APPLICANT: Northeast Nuclear Energy Company  
FACILITY: Millstone Nuclear Power Station, Unit 3  
SUBJECT: SUMMARY OF MILLSTONE 3 SEISMIC II/I MEETING

The purpose of this meeting was to discuss the non-seismic/seismic interaction program for Millstone 3.

MS-3 INTAKE STRUCTURE

SEISMIC INTERACTION REVIEW PROGRAM  
MILLSTONE - UNIT 3 NUCLEAR POWER STATION

Photo No. 1

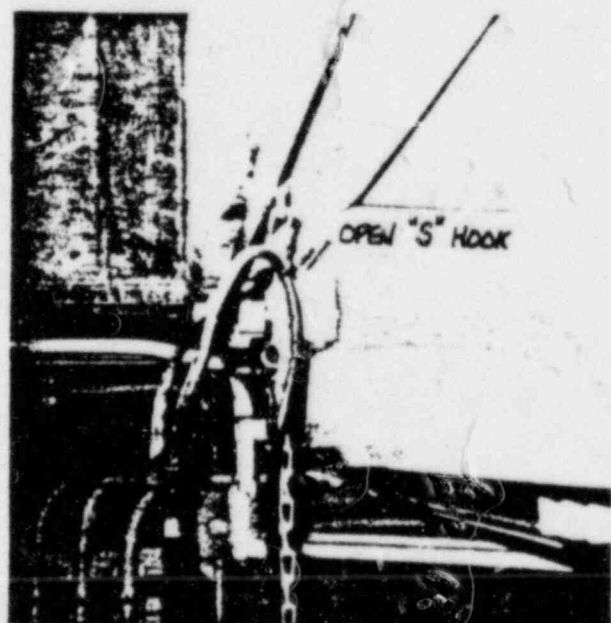
Description: All chain-hung lighting units (6 observed) have open "S" hook @ connections.

Elevation: Historical seismic data has shown that chain-hung lighting fixtures have slipped out of open "S" hook connections during a seismic event thereby resulting in a complete loss of anchorage. Lighting units then become gravity missiles targeting anything beneath them.

Resolution: As a result of this review, E&DCR F-E-38410 was written to provide details/direction for positive anchorage of "S" hook connections. Subsequently, chain-hung lighting units pose no seismic interaction concern.

Interaction No. S-002

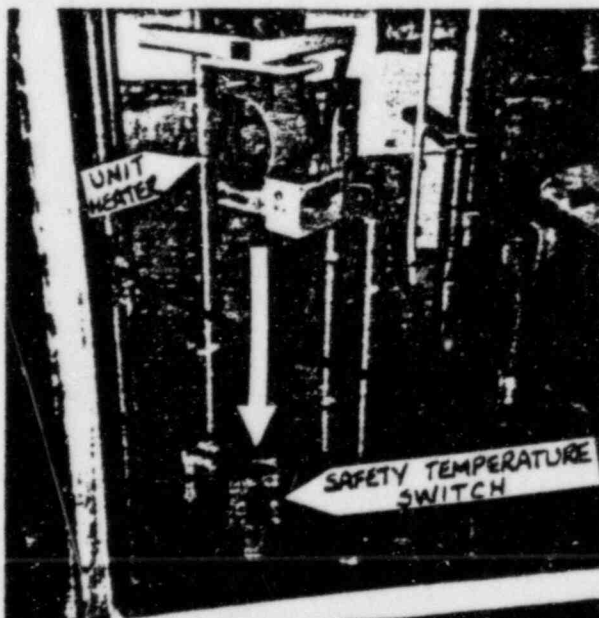
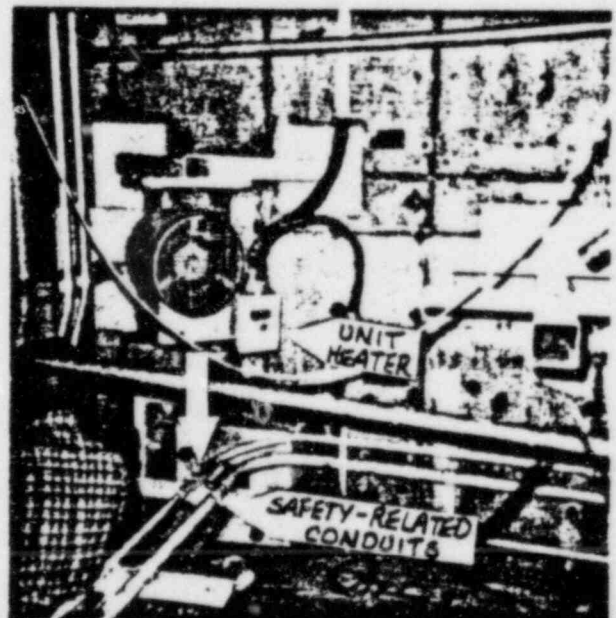
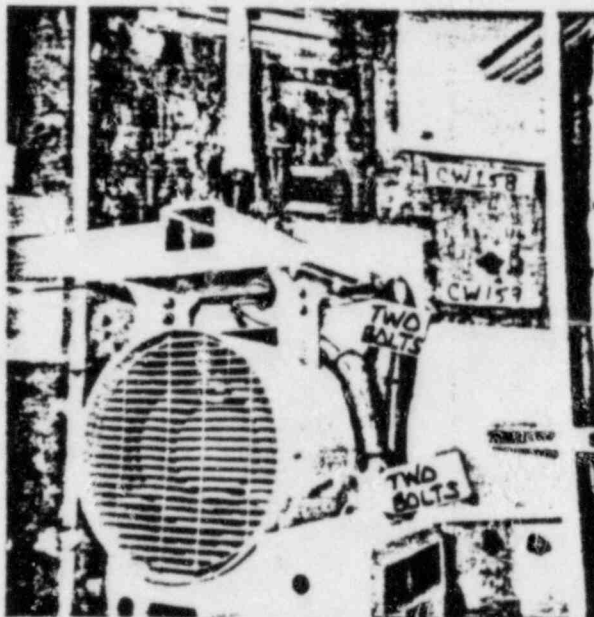
Description: Unit heaters 3HVV-UHE1A and 3HVV-UHE1B are mounted directly above safety-related components (see Photo No. 1 & 2). Loss of anchorage would result in the unit heaters becoming gravity missiles targeting the safety related components.

Evaluation: The unit heater's support has been seismically designed up to the interface with the nonsafety-related unit heater. The unit heater is attached to the seismic CAT II support using two bolts on each side of the mounting bracket (see Photo No. 3).

No credible singular failure mechanism is present in the support configuration. In the unlikely case of one of the bolts failing during a seismic event, adequate load path redundancy provided by the

The unit heater and its support accommodates a high amount of lateral excitation when shaken by hand. In addition, past earthquake survival data has shown that ceiling-mounted equipment such as unit heaters have not lost their anchorage during seismic events.

Unit heaters will not become detached during a seismic event since adequate anchorage is provided. Subsequently, no functional impairment of nearby safety-related components will occur.

Interaction No. S-003

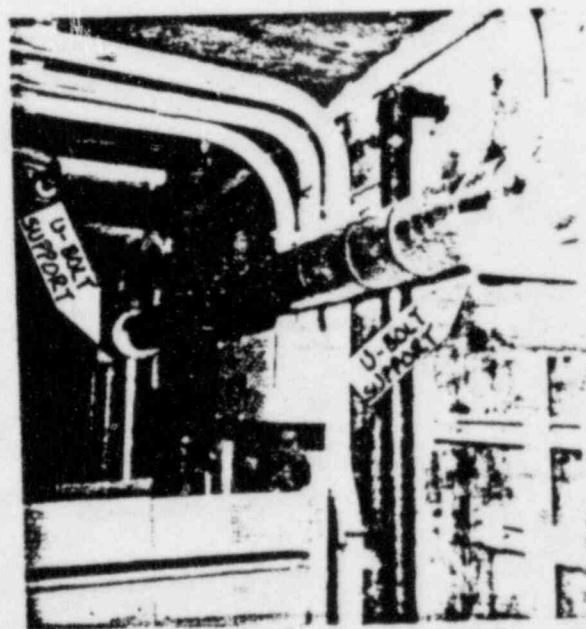
Description: Nonseismically supported 1 1/2" diameter domestic water pipe is unusually close to safety-related conduit 3CC8820G (see Photo No. 1). The available clearance between the two components is approximately 1/2" (w/insulation).

Evaluation: The safety-related conduit is restricted from movement towards the nonseismically supported 1 1/2" water pipe by a seismic U-strap/unistrut support located 7" from the potential point of interaction. The 1 1/2" water pipe is restricted from movement towards the safety-related conduit by U-bolts which secure the pipe to angle iron cantilever supports located on either side of the potential point of interaction (see Photo No. 2).

Due to the close proximity and adequacy of the supports, the relative seismic movement between the components will be very small and adequate clearance will prevail during a seismic event.

Resolution: Seismic interaction between the nonseismic pipe and the safety-related conduit is precluded since adequate clearance exists. Subsequently, no impairment of the conduits safety function will occur.

Interaction No. S-004

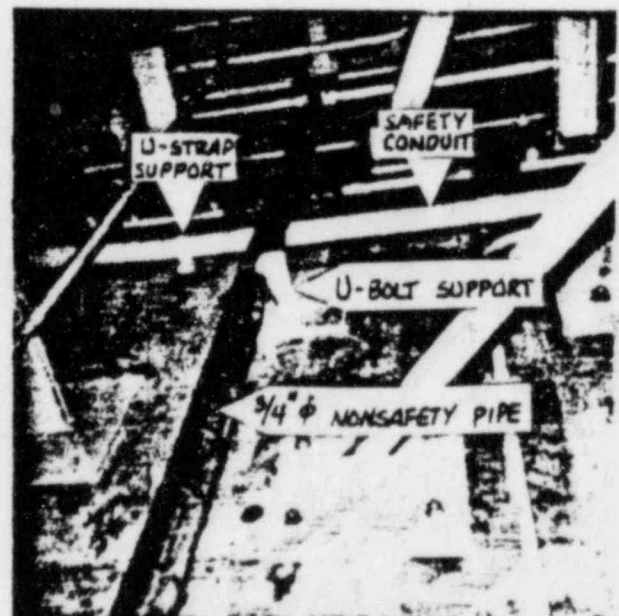
Description: The vertical riser portion of the nonseismically supported domestic water pipe is unusually close to safety-related conduit 3CL883NG. The available clearance between the components is approximately 3/4".

Evaluation: The 3" diameter safety-related conduit is well-supported against movement towards the 3/4" nonseismic pipe by seismic U-strap supports located on each side of the potential point of interaction (see Photo No. 1). The 3/4" nonseismically supported pipe is restricted from movement towards the safety-related conduit by a U-bolt support located approximately 16" from the potential point of interaction (see Photo No. 2).

point of concern, the relative seismic movement between the components will not exceed the 3/4" available clearance between them.

Resolution: A seismic interaction between the nonseismically supported pipe and the safety-related conduits is precluded since adequate clearance exists. Subsequently, no impairment of the conduits' safety function will occur.

Figure No. 1

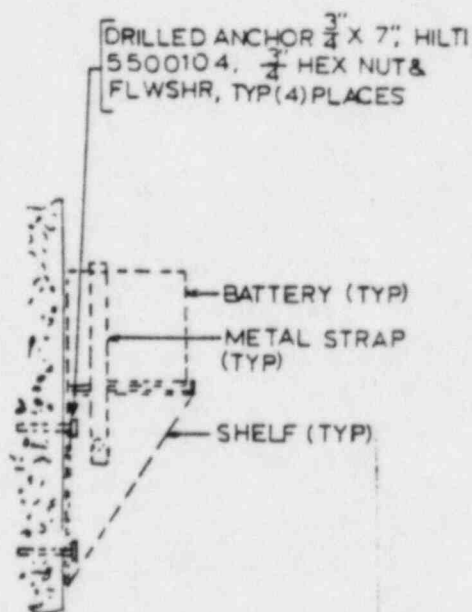
Description: Emergency lighting units are wall mounted in both safety-related service water cubicles (one in each cubicle). A loss of anchorage would result in the lighting units becoming gravity missiles targeting safety-related components (see Photo No. 2).

Evaluation: The mounting brackets upon which the battery-powered lighting units rest are firmly attached to the wall using (4) - 3/4" diameter anchor bolts.

The lighting units are kept from overturning/sliding off the bracket by metal hold-down straps (see Photo No. 1 and Figure No. 1).

The lighting unit and its support accommodates a high amount of lateral excitation when shaken by hand. In addition, past earthquake survival data has shown that wall-mounted equipment such as emergency lighting units have not lost their anchorage during seismic events.

Resolution: Emergency lighting units will not become detached during a seismic event since adequate anchorage is provided. Subsequently, no functional impairment of nearby safety-related components will occur.

Interaction No. S-024

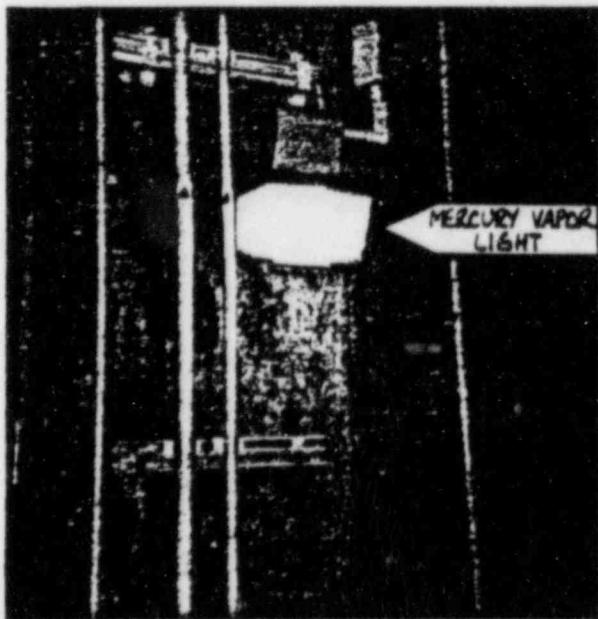
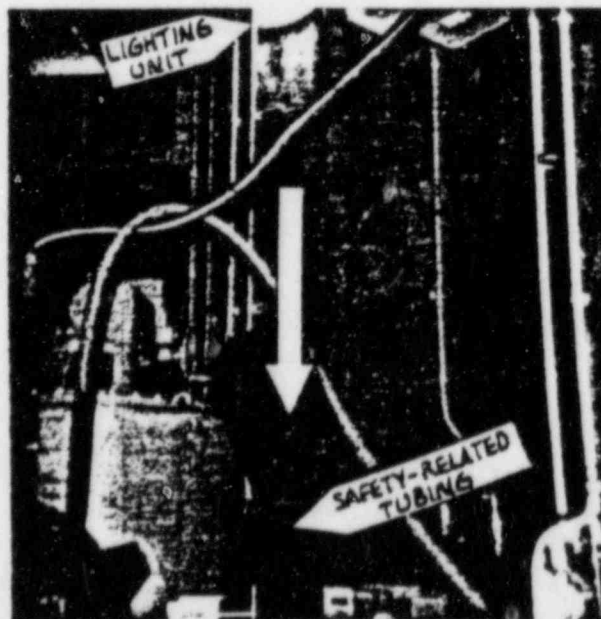
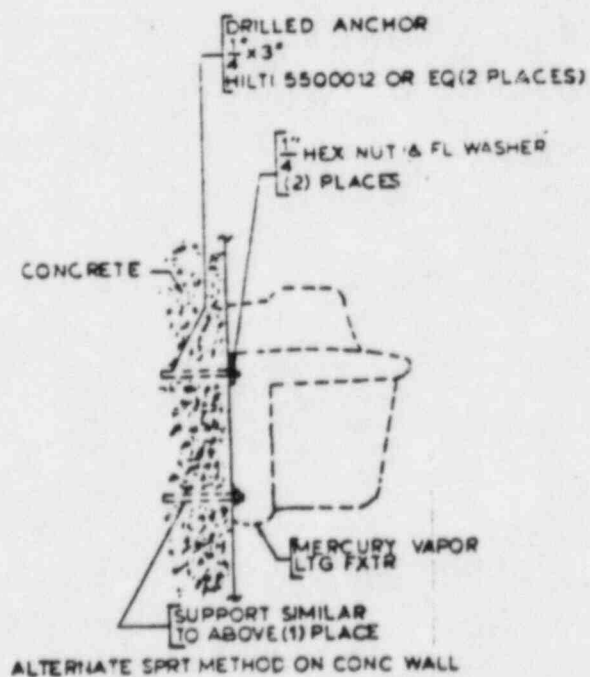
Description: Mercury vapor lighting units are wall-mounted in both safety-related service water cubicles (see Photo No. 1). A loss of anchorage would result in the lighting units becoming gravity missiles targeting safety-related tubing and other components located below (see Photo No. 2). The same hazard concern is in each cubicle.

Evaluation: The lighting units are firmly attached to the wall using (4) - 1/4" diameter anchor bolts (see Figure No. 1).

No credible singular failure mechanism is present in the support configuration. In the unlikely case of one of the bolts failing during a seismic event, adequate load path redundancy provided by the

Past earthquake survival data has shown that wall-mounted equipment such as lighting units have not lost their anchorage during seismic events.

Resolution: Mercury vapor lighting units will not become detached during a seismic event since adequate anchorage is provided. Subsequently, no functional impairment of nearby safety-related components will occur.

Interaction No. S-025

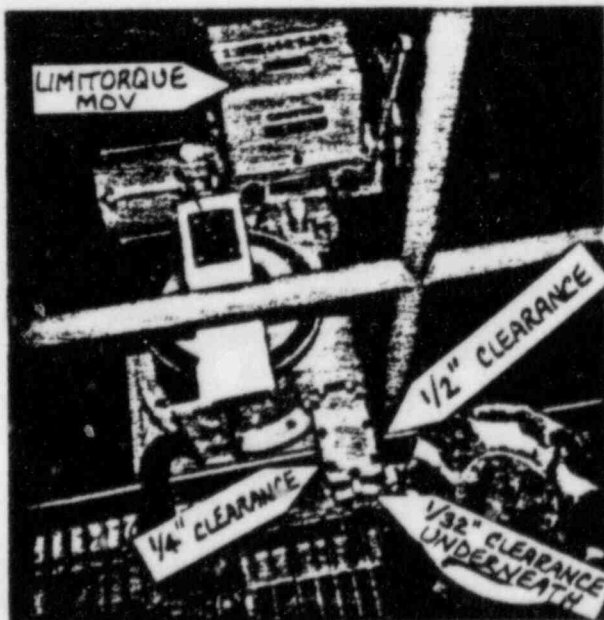
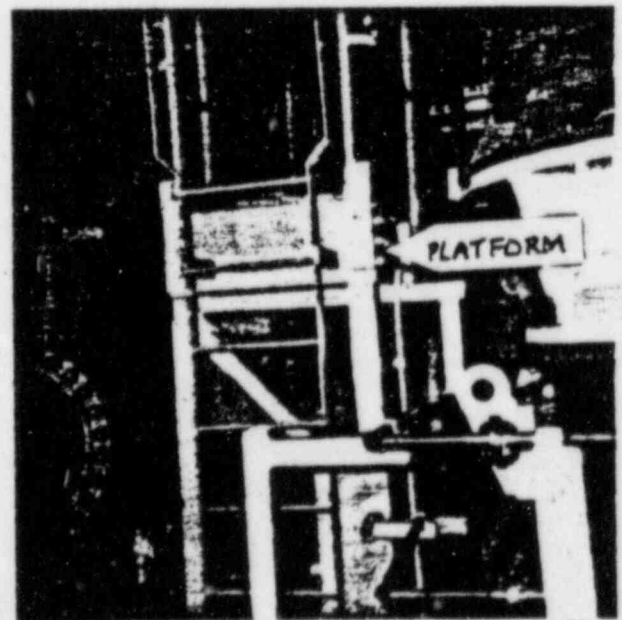
Description: At elevation 21'-9", the safety-related limitorque motor operated valve housing is unusually close to the edges of the raised platform. The available clearances between the two components are as shown on Photo No. 1.

Evaluation: The raised platform is adequately supported using robust structural steel members with diagonal bracing (see Photo No. 2). The platform has been designed to withstand seismic loads. Likewise, the safety-related motor operated valve is very securely mounted to the 30" diameter service water pipe and has been designed and constructed to Seismic Category I standards.

Nevertheless, the acceptability of this configuration cannot be determined by a visual/judgemental assessment because of the

tight clearances and the unpredictability of the relative seismic movement between the two components during a seismic event.

Upon further investigation, a comparison between the analyzed seismic displacements of the safety-related motor operated valve/30" diameter pipe and the raised platform reveals that adequate clearance exists between the two components during a seismic event.

A seismic interaction between the edge of the raised platform and the safety-related motor operated valve housing is precluded due to adequate clearance between the two components. Subsequently, no impairment of the motor operated valve's safety function will occur.

Photo No. 3

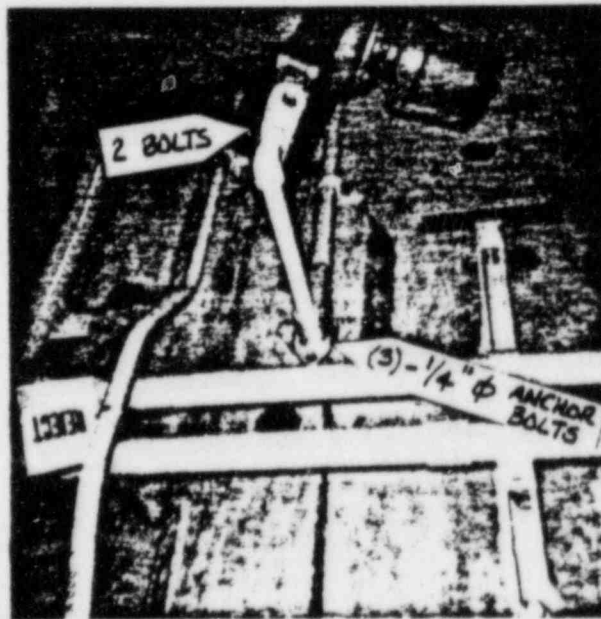
Description: Nonseismically supported loudspeakers are mounted in both service water pump cubicles which contain safety-related components (see Photos 1 & 2). A loss of anchorage would allow the loudspeakers to fall and possibly impact safety-related components.

Evaluation: The nonsafety-related loudspeaker's support is mounted to the wall using (3)-1/4" diameter anchor bolts. The loudspeaker is attached to the support using two bolts (see Photo No. 3).

No credible singular failure mechanism is present in the support. If one of the bolts should fail during a seismic event, adequate load path redundancy provided by the remaining bolts precludes a complete loss of anchorage of the unit.

The loudspeaker and its support accommodates a high amount of lateral excitation when shaken by hand. In addition, past earthquake survival data has shown that wall-mounted equipment such as loudspeakers have not lost their anchorage during seismic events.

Loudspeakers will not become detached during a seismic event since adequate anchorage is provided. Subsequently, no functional impairment of safety-related components will occur.
